Hornsea Project Four

Clarification Note on Marine Processes Mitigation and Monitoring

Document Reference: G5.33

Figure 1 Smithic Bank and 2021 Survey Data

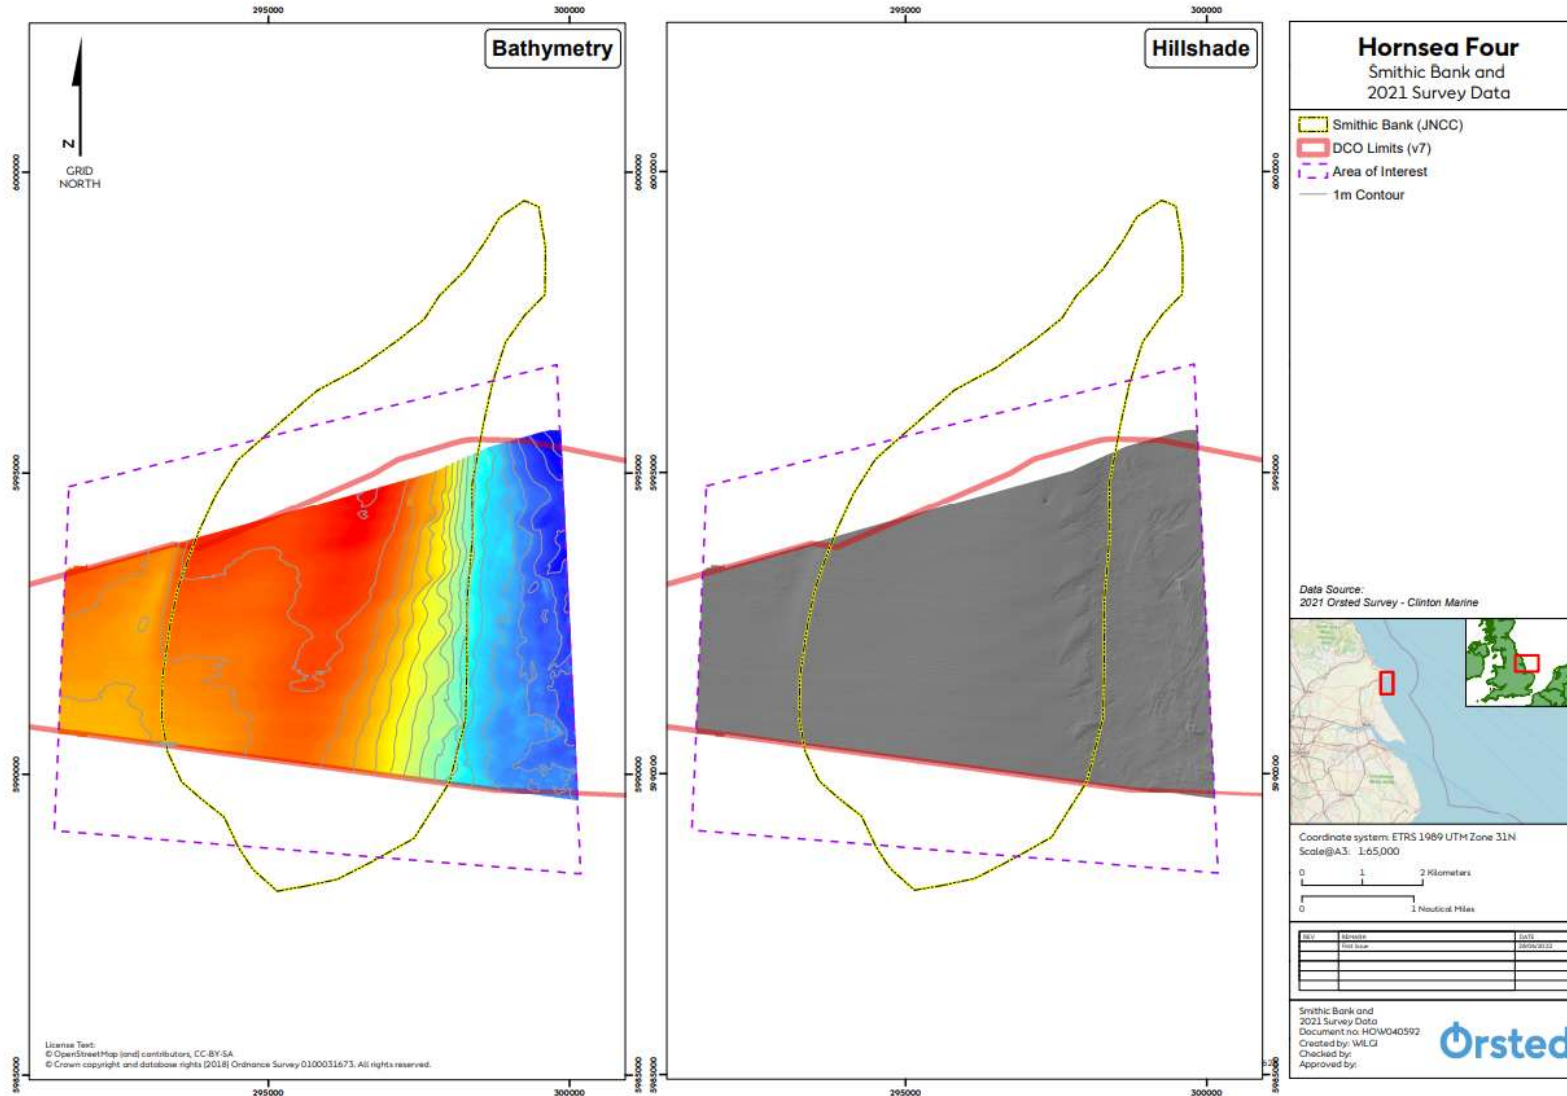
4.3.1.1 A key premise for monitoring across Smithic Bank and the Dogger Bank crossing is that the boundary of the bank is understood. For the purposes of monitoring, this boundary is the one developed by JNCC for the designation of the feature (for which Smithic Bank wasn't selected for designation and therefore is a sandbank, as any other sand banks in the southern North Sea, of which there are significant numbers) and the shapefile/boundary used to inform all works and assessment to date.

4.3.1.2 The boundary is used to verify the pre-construction distance to the east to the Dogger Bank A & B Cable Crossing and based on the location of recently installed cables. An alternative boundary was proposed by MMO, Cefas and Natural England as the geomorphological boundary of the Smithic Bank. [Figure 1](#) presents the JNCC Smithic Boundary with the 2021 Orsted (Clinton Marine) 2021 geophysical survey with hillshade analysis. The data sets shown broad general agreement between the JNCC shapefile and geomorphological boundary (see Hillshade inset).

Figure 2 Dogger Bank AB Cable Crossing in Relation to Smithic Bank

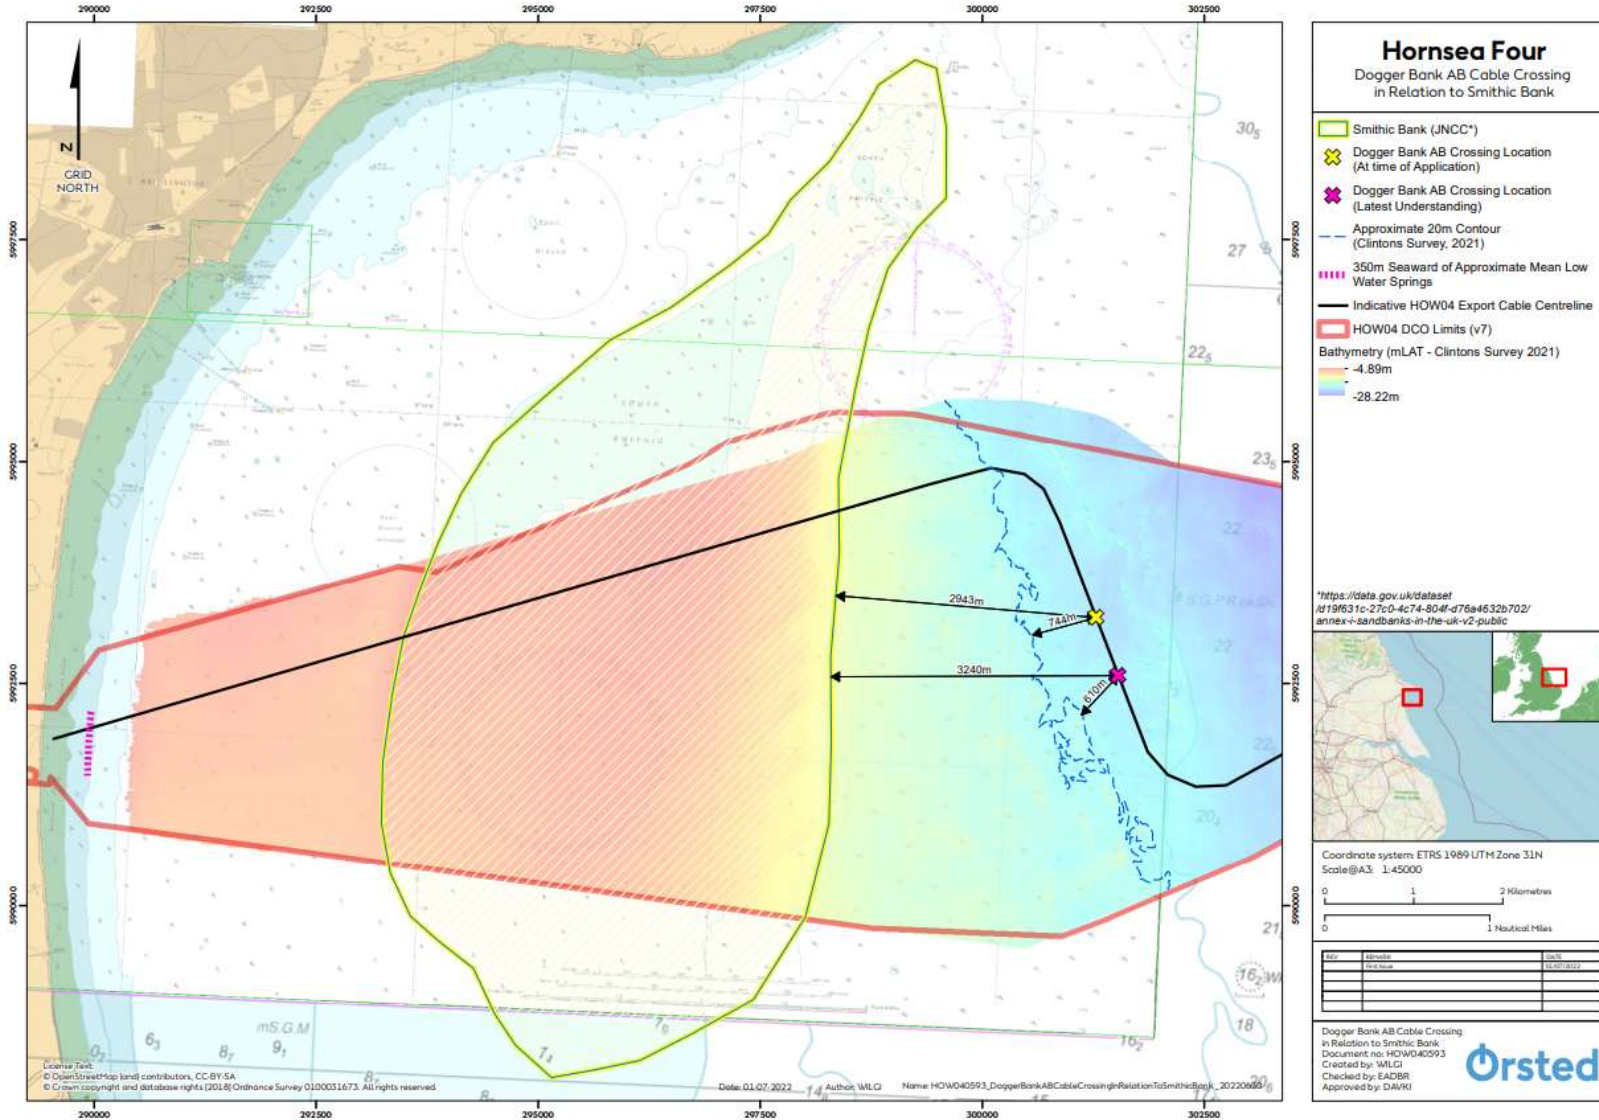
<p>The Dogger Bank A & B Cable Crossing should be sited as far to the east of the accurately defined geomorphological boundary as possible.</p>	<p>Smithic Bank</p>	<p>The Applicant has concluded some analysis to confirm the geomorphological boundary of the Smithic Bank (REF). The Applicant confirms that the JNCC shapefile for Smithic Bank is a good representation of the geomorphological boundary as it broadly aligns with the sandwaves/bedforms and change in bed roughness on the eastern flank of the bank. Therefore, the JNCC boundary is used as the datum for all monitoring works proposed as it is an agreed upon and openly available boundary not subject to debate or uncertainty.</p> <p>The Applicant has already committed (see Co189 in A4.5.2: Commitment Register) to ensuring the Dogger Bank A & B cable crossing is positioned as far east as is currently possible, past the 20 m contour east of the Smithic Bank.</p> <p>A final decision on the implementation of further mitigation is dependent upon receipt of the final location of the Dogger Bank A & B, cables, confirmation of the Hornsea Four decision on HVAC (6 cables) or HVDC (2 cable) electrical system and the appointment of a principal contractor. The Principal Contractor is responsible for the production of the CBRA before the Applicant is able to confirm cable protection requirements or exact location.</p>

- 4.3.1.3 The boundary between the Dogger Bank A & B Cable Crossing, based on the location of recently installed cables, and the eastern boundary of Smithic Bank is presented in [Figure 2](#). The distance is 2.9 km (At time of Application) or 3.2 km (Latest Understanding).
- 4.3.1.4 [Table 6](#) outlines the proposed approach to monitoring of Smithic Bank. The monitoring is proposed to be captured in an updated Outline Marine Monitoring Plan ([APP-242](#)) to be submitted at Deadline 6.
